**Appeal by Great Lakes UK Limited
Proposed Great Wolf Lodge, Chesterton**

Appeal Ref: APP/c3105/W/20/3259189

Proof of Evidence

**On matters relating to transport planning and traffic
impacts**

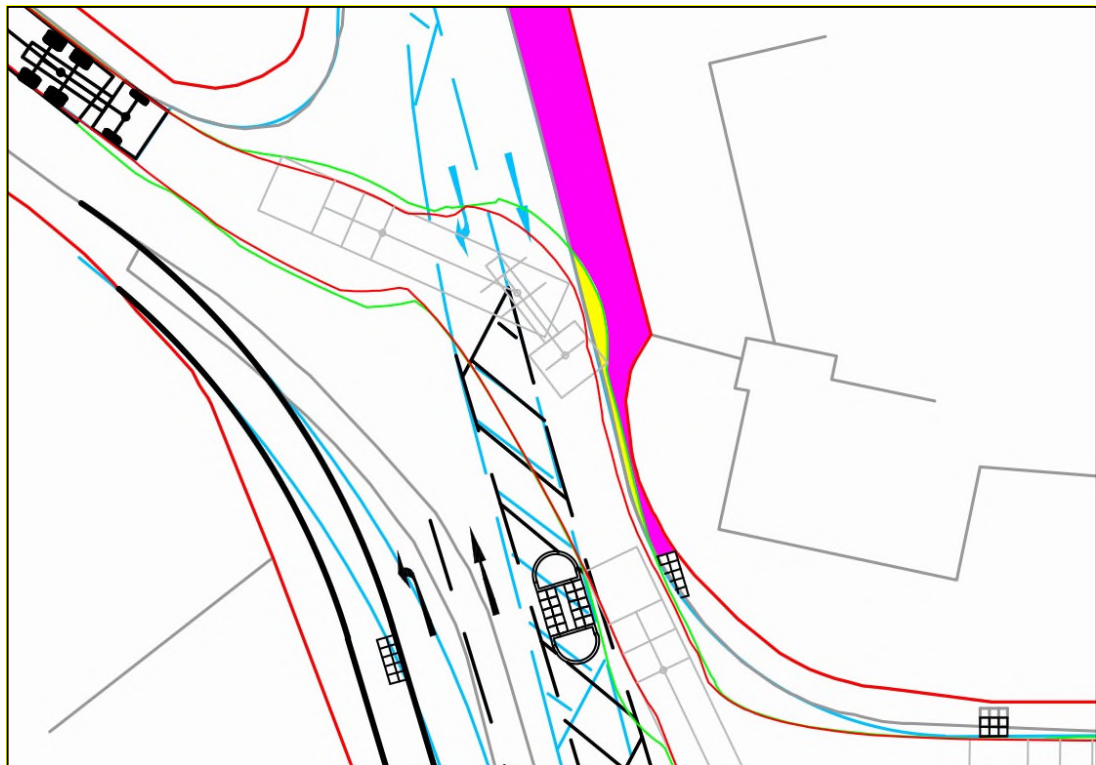
Problem 5: Risk of vehicles, cyclists and pedestrian colliding with street furniture.

- *'Street furniture and lighting details are not available to the Audit Team and it is acknowledged this will be a detailed design matter, for consideration at Stage 2 RSA. However, if street furniture is not mounted appropriately it could be struck by pedestrians, cyclists or vehicles.'*

- 3.123. In the Technical Note (N09, dated 30 July 2020, the Appellant notes that OCC requested a Stage 1 and 2 Road Safety Audit. The Appellant then notes that *'it is not normal practice for a Stage 2 Road Safety Audit to be undertaken at the Planning stage as this required the detailed design of the highway works'*. The note then goes on to state that, in the Appellant's view, the RSA *'raises no material concerns with the proposed mitigation scheme and all comments raised in the Audit can be addressed as part of the detailed design stage...'*. before being re-examined in a stage 2 Audit.

- 3.124. However, I would observe that to address the risks identified is likely to require material alterations to aspects of the currently proposed layout. As further discussed below, I find that the layout presents considerable risks to pedestrians and that from a vehicle swept path perspective, the junction cannot be shown to work. In this regard, I agree with the findings of the Stage 1 Road Safety Audit.

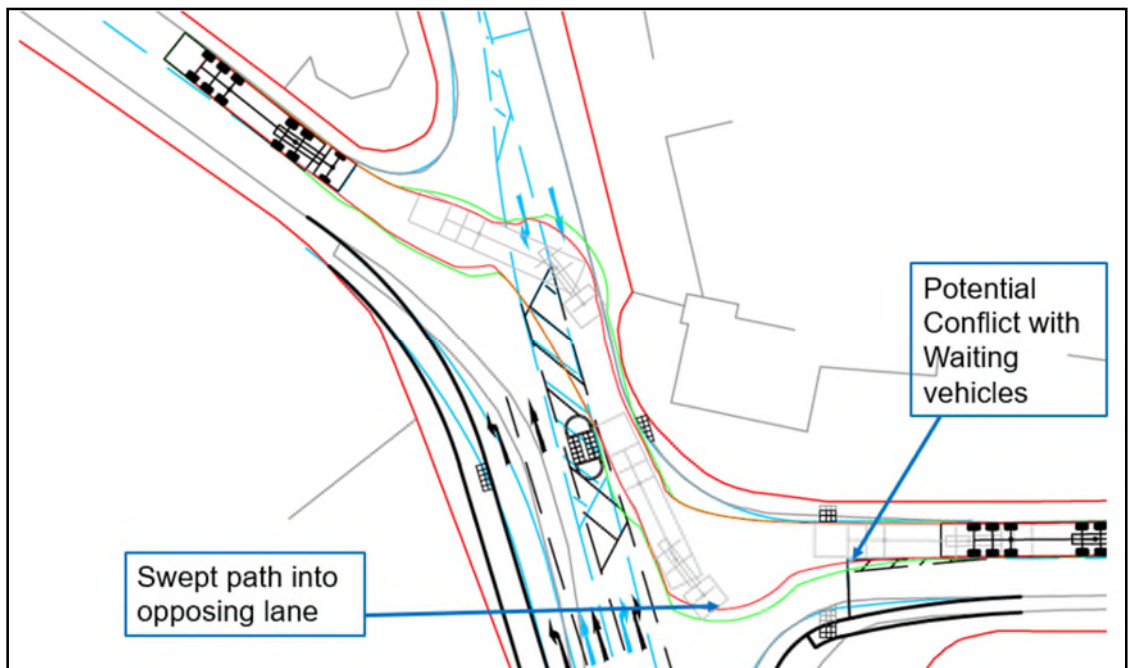
3.133. I would strongly disagree with this statement. With reference to an excerpt of Drawing 1803047-TK62, I would note that the swept path details show an articulated vehicle protruding into the footway when making this manoeuvre which if replicated in a real-life situation, would present a serious risk to pedestrians. I have overlaid colour to the drawing to highlight the extent of the established footway (shown in pink) and the encroachment of a heavy goods vehicle into that space (shown in yellow).

3.134. The Appellant's statement that large vehicles '*can manoeuvre appropriately without conflicting with the pedestrian refuge*' should be viewed in the context that as part of the same manoeuvre, it is necessary for such vehicles to encroach into pedestrian space. As my own review of the junction demonstrates below, I consider that if the truck did not encroach into the footway to the north east of the pedestrian refuge island, a vehicle of this length would be unable to complete the manoeuvre without conflict with the refuge island.

3.135. This is a completely unacceptable proposition which I find to be contrary to policy, contrary to good practice and contrary to the safety of pedestrians.
